Customer Notification

Flash Programmer

PG-FP4-E

Operating Precautions

No. 1 IIC communication

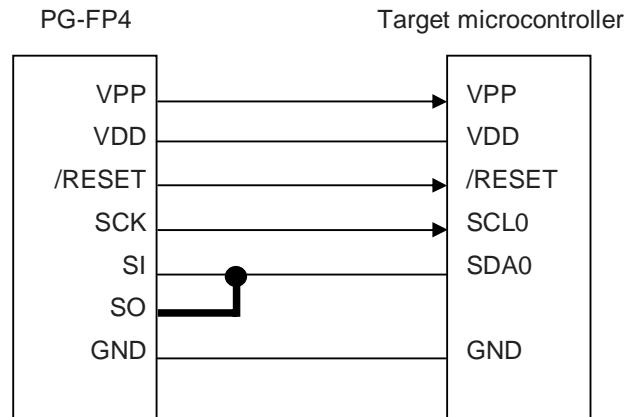
The IIC communication mode adapter board is included.

When using IIC communication mode with PG-FP4 control code B, short the SI and SO pins in the PG-FP4.

The IIC communication mode adapter board is included in products with control code C (firmware: V1.17, GUI: V2.00) and later. Use the IIC communication mode adapter board for IIC communication.

No. 32 Modification of percentage display when a verify error occurs in block mode with single-power-supply flash memory microcontroller

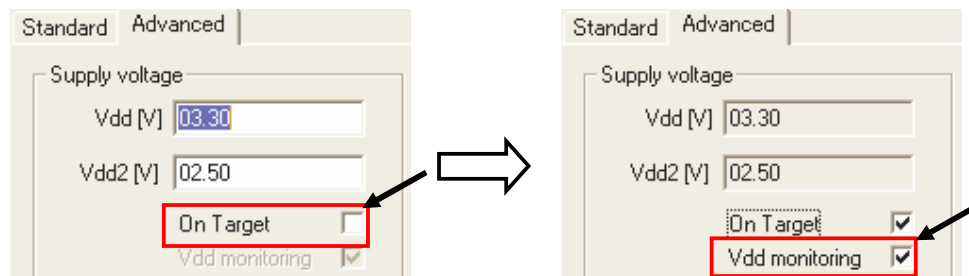
When a verify error occurs in block mode with single-power-supply flash memory microcontroller, the final display percentage does not reach 100% depending on the device used. The specification has been modified so that a percentage indication of up to 100% is displayed.

This item has been implemented in products with control code G (firmware: V1.33, GUI: V2.15) and later.

(3) [Checksum] menu specifications

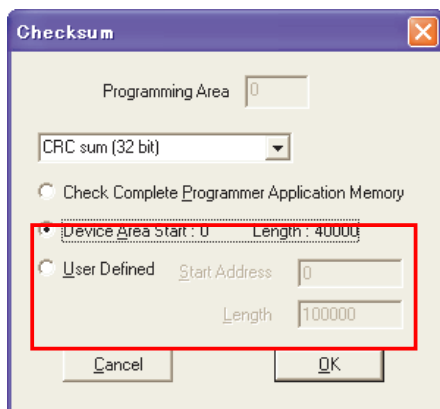
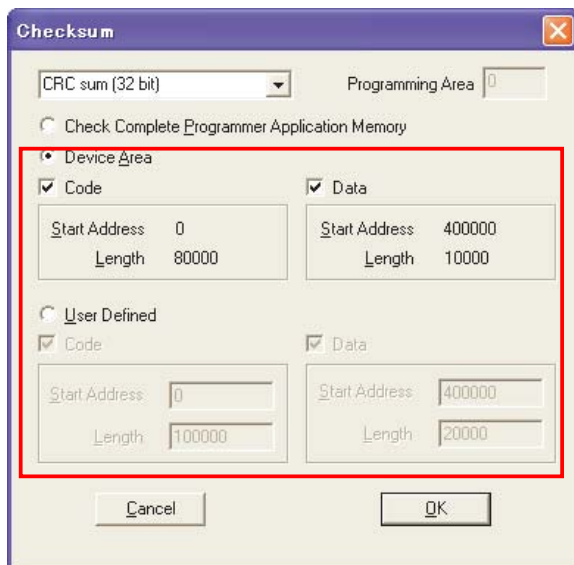
When [Checksum] in the [File] menu is executed, the window display varies depending on whether or not the downloaded parameter file supports the data flash area.

(4) [HEX Editor] menu specifications

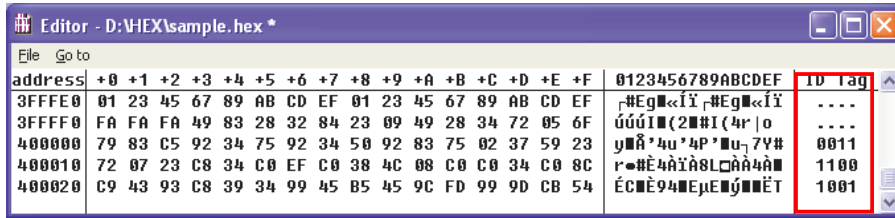
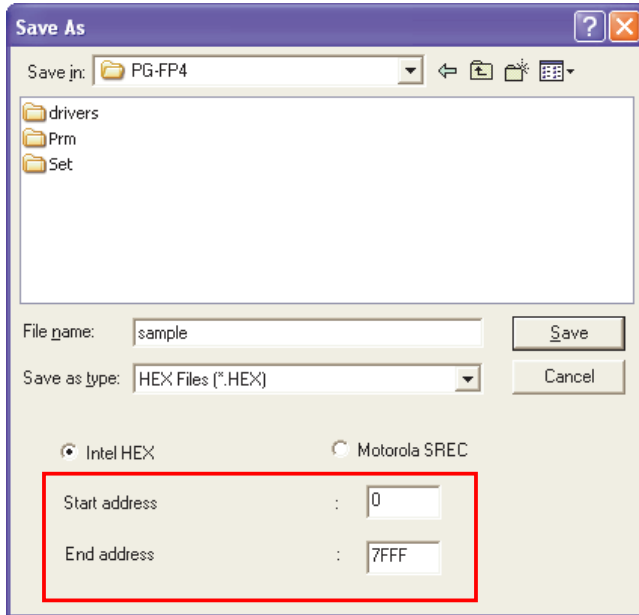
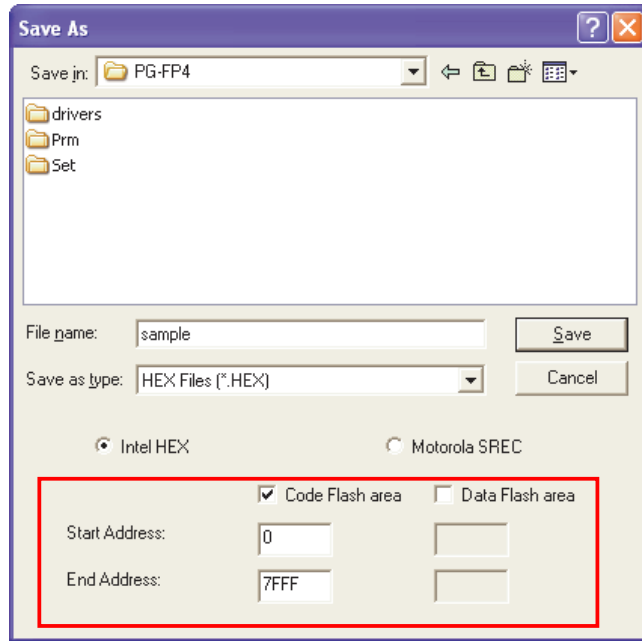
An ID Tag row has been added to the [HEX Editor] in the [File] menu. The ID Tag row is used in microcontrollers that support the data flash area. Only the values at addresses 400000h and beyond can be edited in the ID Tag row.

When a parameter file is downloaded using the [HEX Editor] and the file is saved as, the available options in the [Save As] window vary depending on whether or not the downloaded file supports the data flash area.
